Department of Planning and Community Development
Statutory Approvals – Central City Planning
Delegation Report

1. To brief you on Planning Permit Application No.: 2012/004954 for buildings and works for the lower part of Building 5 (below RL35.00 metres) and for the Maltstore, and associated vehicular access from Bouverie Street, at the Former Carlton United Brewery Site, 2-76 Bouverie Street, Carlton.

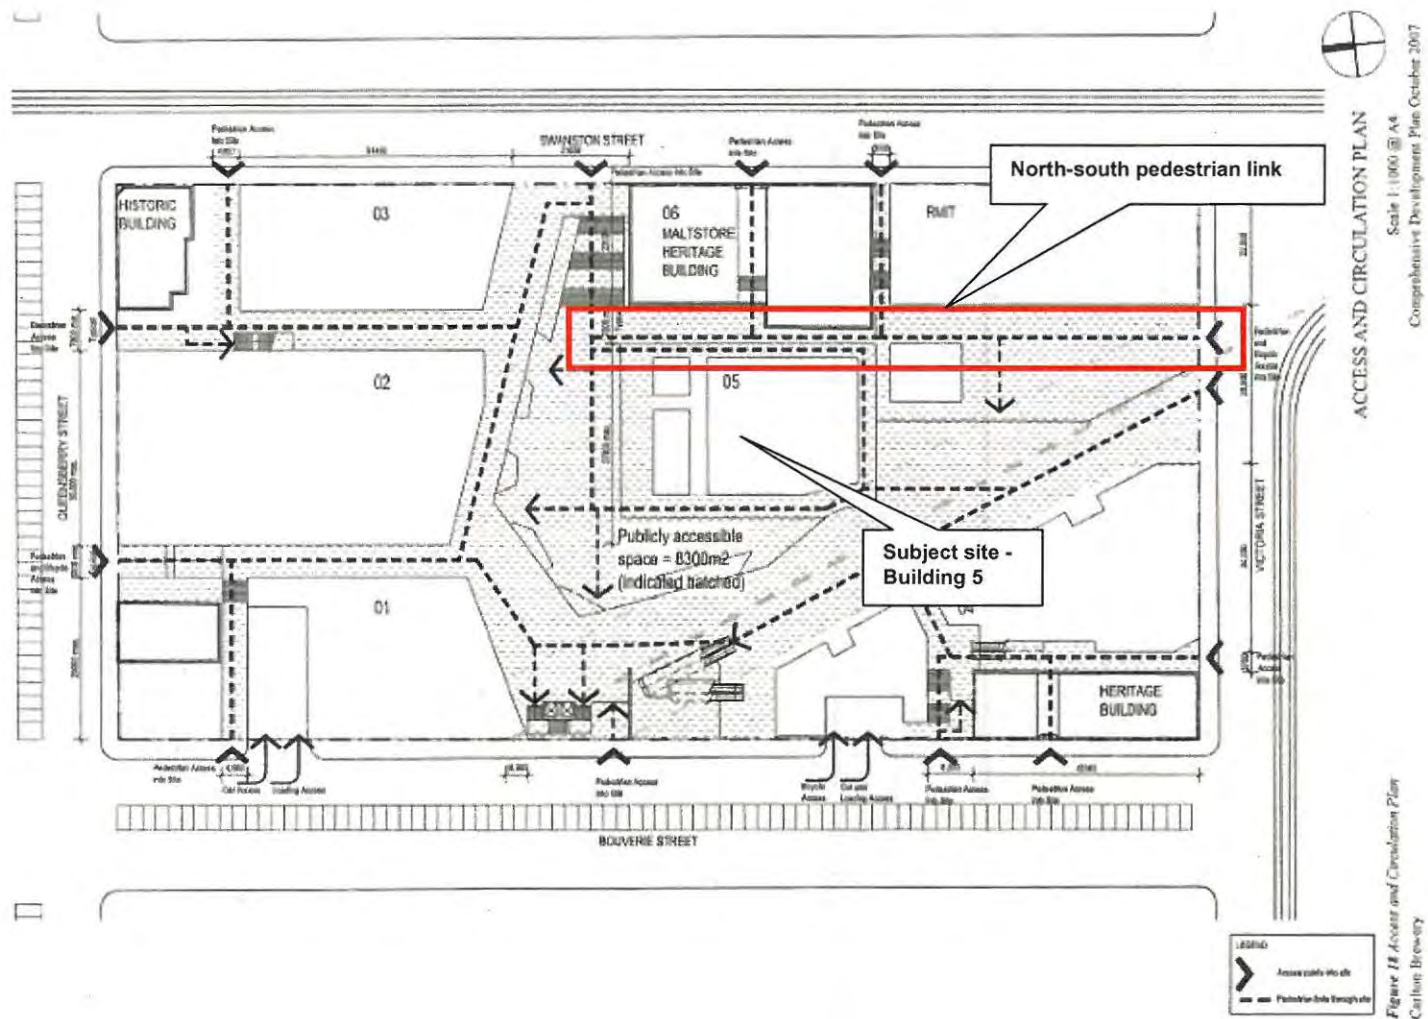
basement convenience retail and car parking, and multilevel connectivity. In particular, the main issues the proposal presents in relation to the Masterplan/CDP are service vehicle access to RMIT's loading bay and north-south pedestrian access through the site to RMIT's Plaza area. These are discussed in detail below.

45. The CDP and Masterplan indicate critical north-south pedestrian link located on the eastern side of Building 5 from the proposed Ballarat Street connecting to both the RMIT Design Hub Plaza and the east-west link that runs from Swanston Street to Madeline Avenue along the southern side of Building 5 (**see figure below**). Moreover, the Masterplan states that the lower level Plaza between RMIT's Design Hub and Archive Centre provides amenity to the RMIT building as well as a linkage to the rest of Carlton brewery.

46. The adjacent RMIT Design Hub and Archive Centre are separated by a publically accessible open Plaza area which is ramped from Victoria Street at RL22.00 down to a lower ground level at RL19.00 at the northern end of RMIT's site. A retail/cafe tenancy fronts onto this Plaza area at RL19.00. The endorsed plans for the RMIT Design Hub show a 8 metre high 'fytowall' greenwall rising from RL19.00 to RL27.00 that extends along the entire length of the common title boundary with Building 5 and the Maltstore.

47. Further to an informal design workshop [REDACTED] a design resolution for the pedestrian access was agreed to which would result in the inclusion of a staired pedestrian access located between the Maltstore and Building 5 at RL27.00 to RMIT's Plaza area at RL19.00. Conditions have been included on the permit requiring amended plans showing this staired pedestrian link and requiring Grocon and RMIT to enter into a section 173 agreement to ensure the pedestrian access is open to the public. This north-south link will achieve the Masterplan's objective of creating a highly permeable site, an attractive and safe environment, and encouraging pedestrian activity and a vibrancy at street level.
